Packet Guide
City of Charlottesville
Board of Architectural Review
Regular Meeting
July 19, 2022, 5:30 p.m.
Hybrid Meeting (In-person at CitySpace and virtual via Zoom)

Regular Meeting

BAR.01

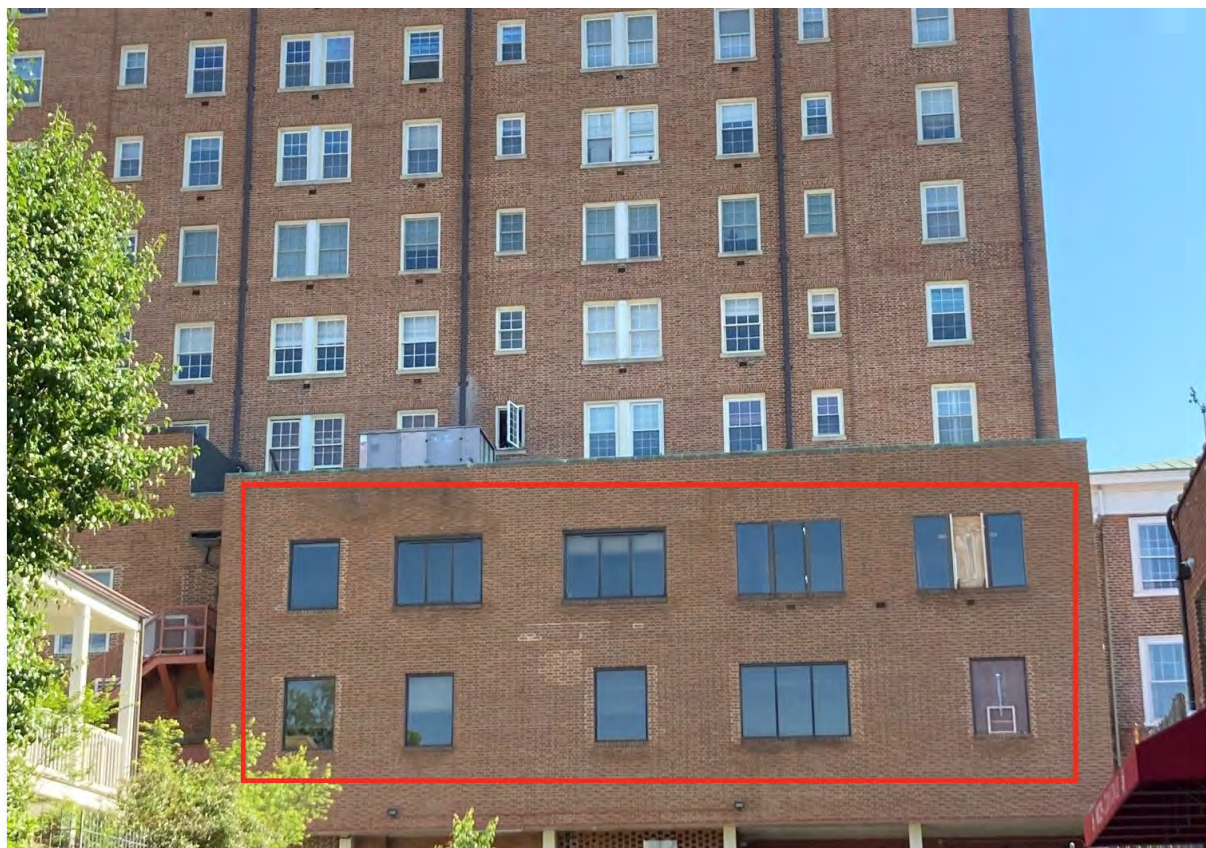
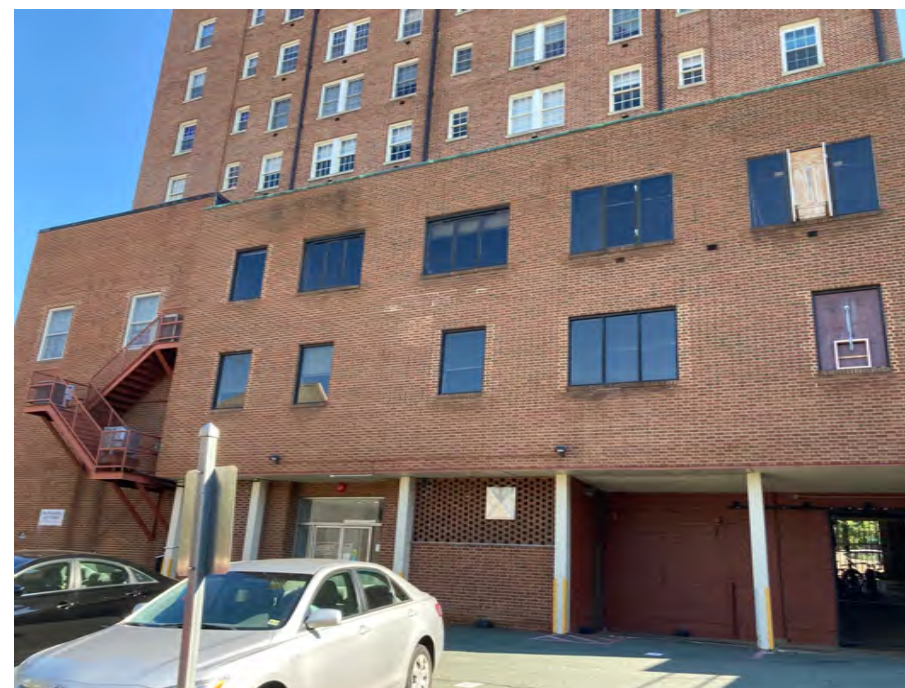
CoA to replace non-historic windows on second and third floors of south addition and extend the rear fire escape to ground and install fire escape door at third floor. (Installing the door and the lower section of the fire escape will replace previously removed elements.)

Replacement windows will be white aluminum clad, double hung Marvin Ultimate windows. Existing brick sills will be retained.

1 SIDE ELEVATION
A-1 1/4" = 1'-0" 0 4'

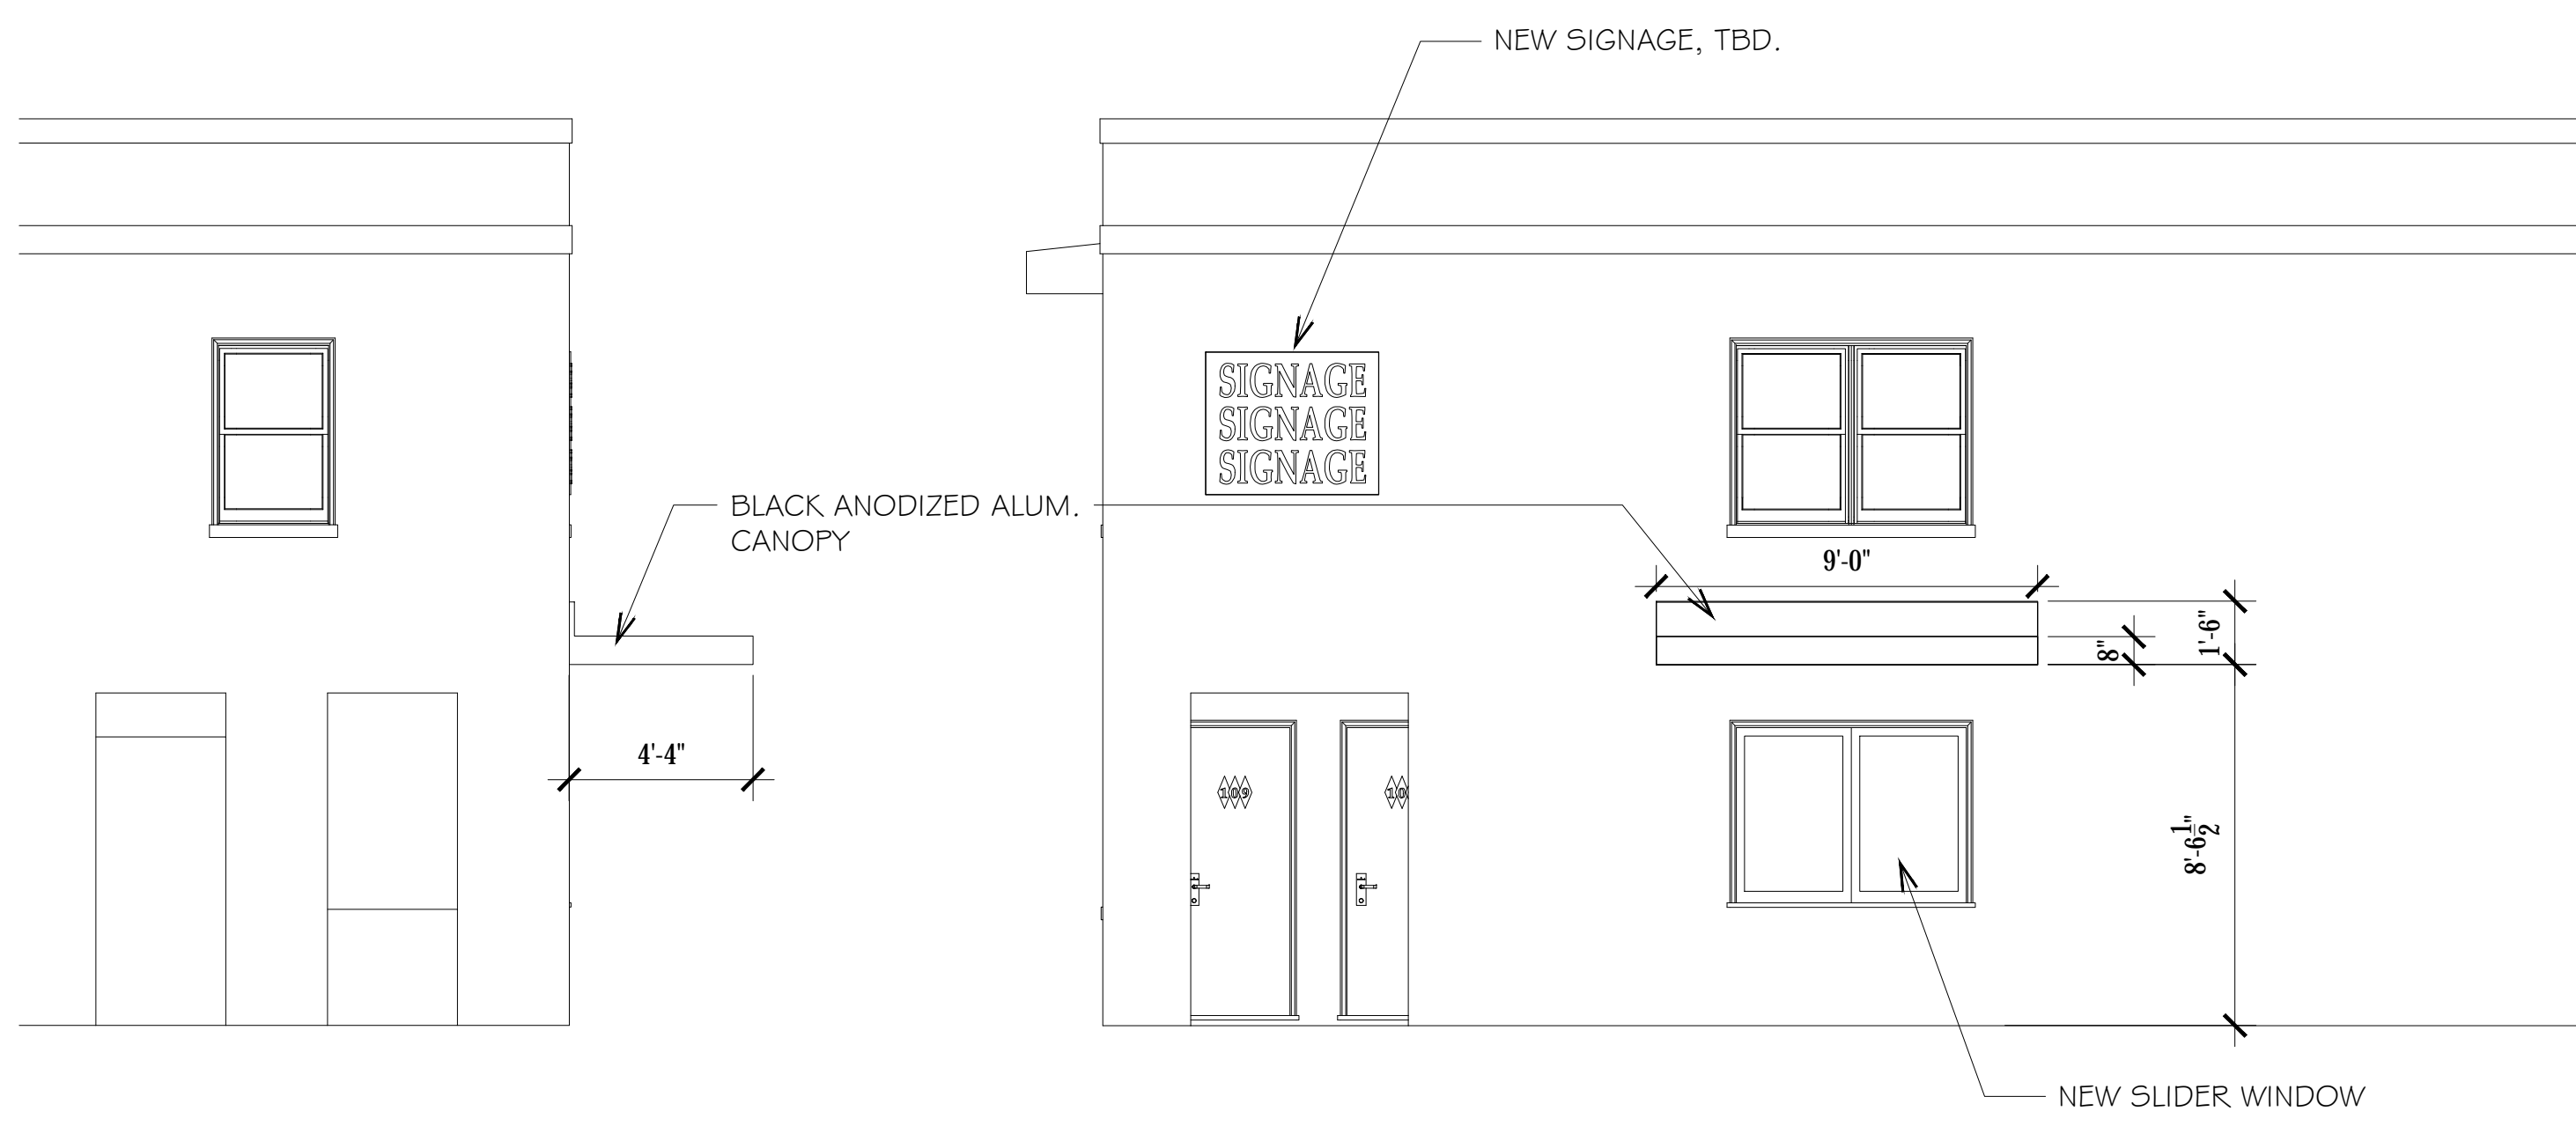
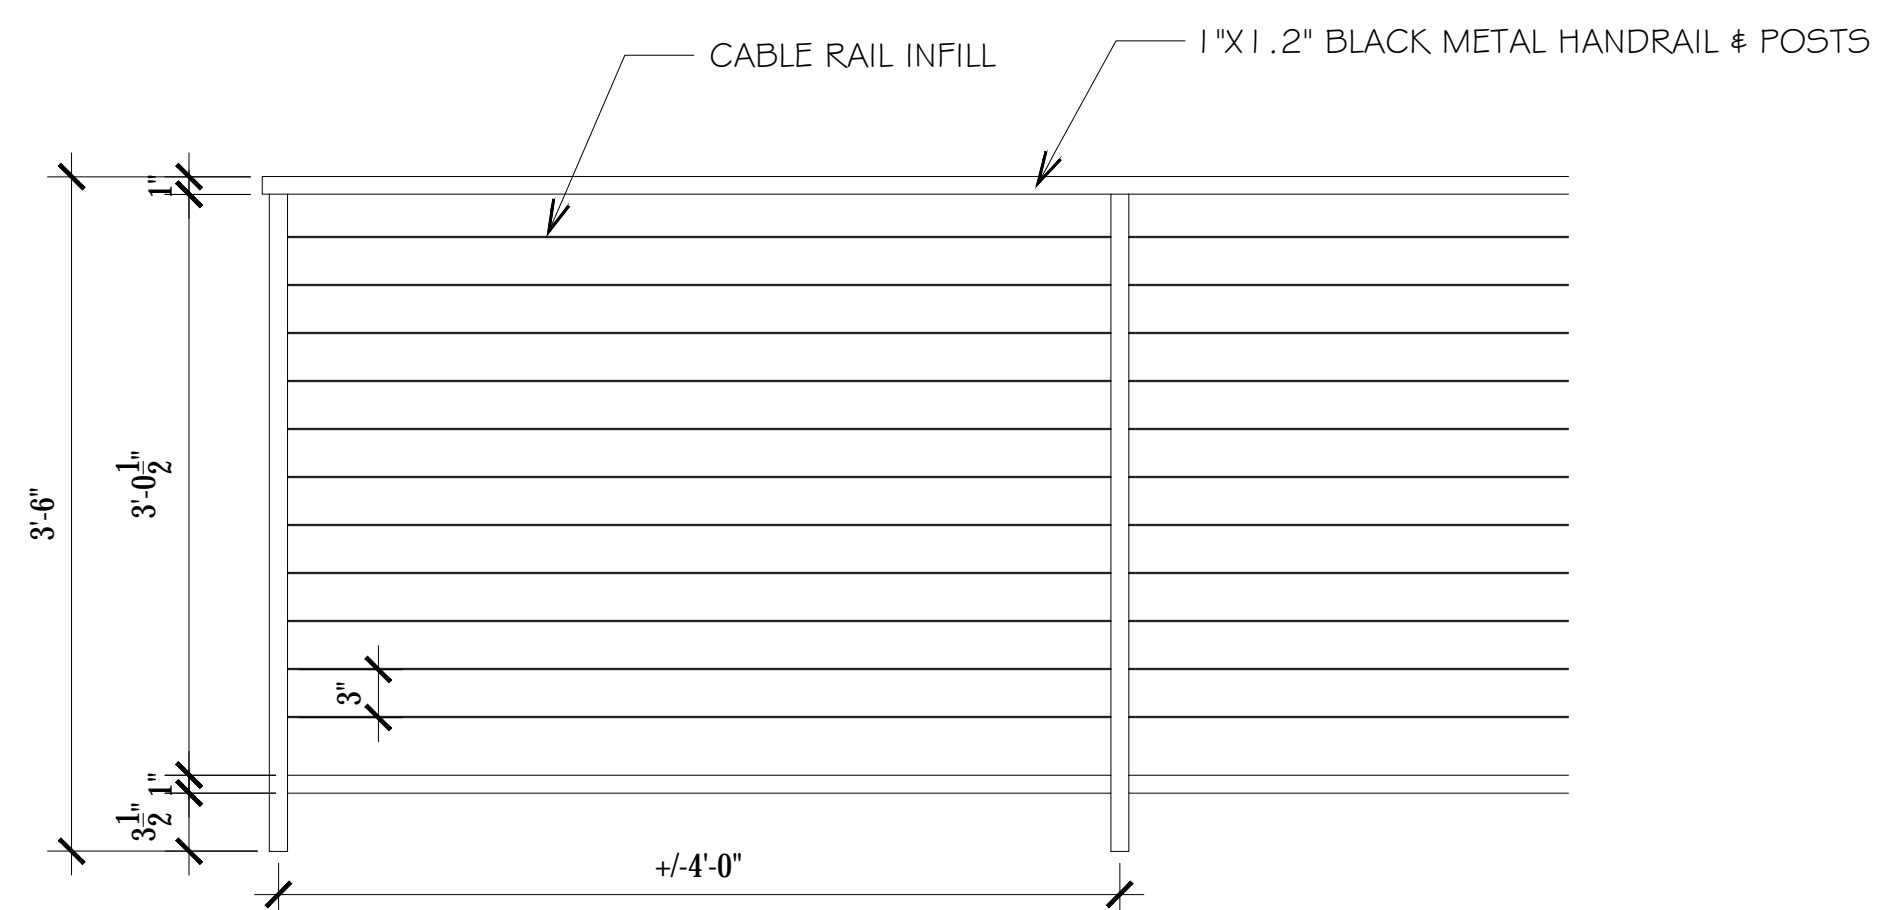
- Period railings to be retained. At 2nd floor, install taut-wire rail behind existing railing to meet code requirements. (Sheet A-1.)
- Replace exterior wall sconces at each room with new. (Supplemental information sheet 7.)

GLIDING WINDOW

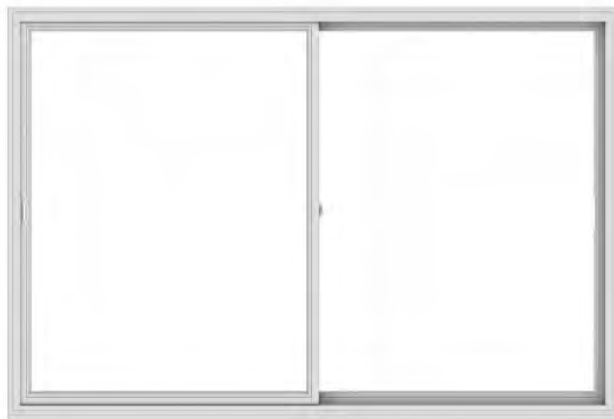
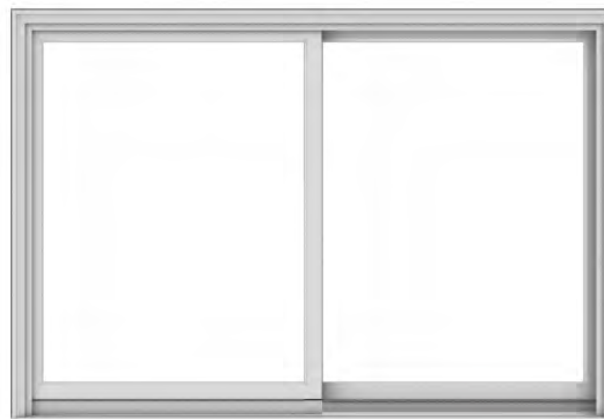
Ground floor, east elevation: remove existing double-hung windows and install wood/alum-clad sliding window. Install aluminum awning above.

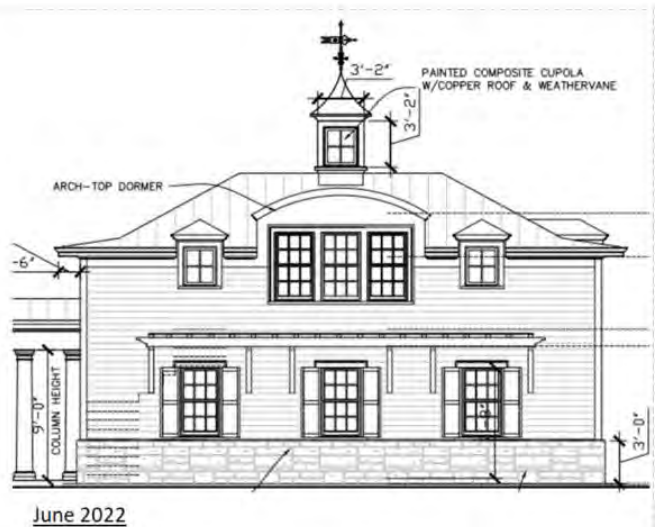
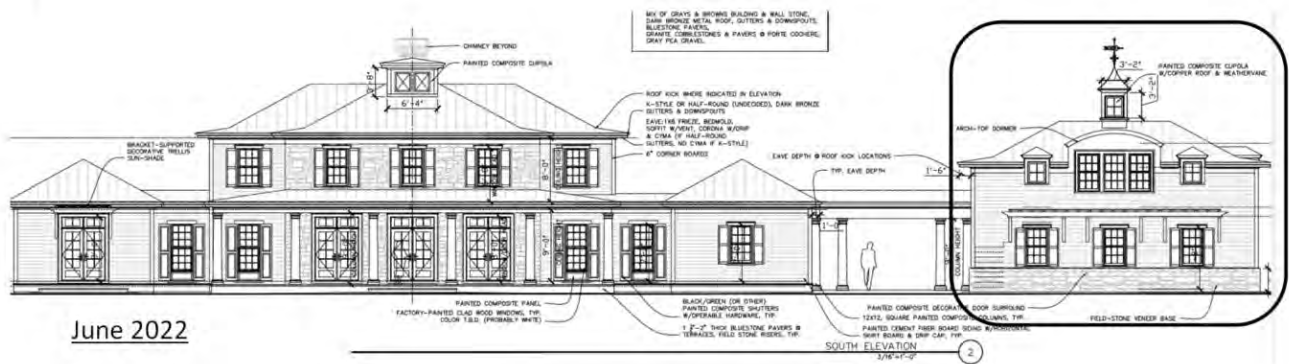
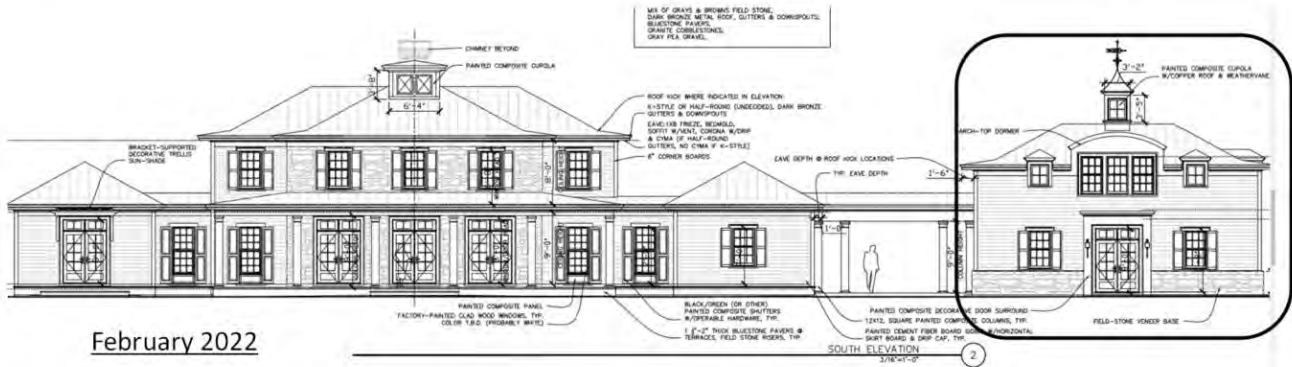
Staff Comment: The Design Guidelines suggest that building detail and ornamentation relate to the surrounding context. Staff finds the proposed style and details similar to those found in the subarea; however, the building reads as a contemporary structure. During the preliminary discussion, the BAR expressed concern that some elements—for ex., the garage cupola—are more elaborate than those found nearby. Staff agrees the proposed house has a greater degree of elaboration than its neighbors; however, the proposed design and materials are not incompatible with the subarea.

Regarding the site, staff is concerned that a substantial amount of the front yard is consumed by the driveway and parking area. Chapter II of the Design Guidelines (Site Design & Elements) recommend placing parking in the rear:

Staff recommends a condition of approval requiring that engaged columns be square
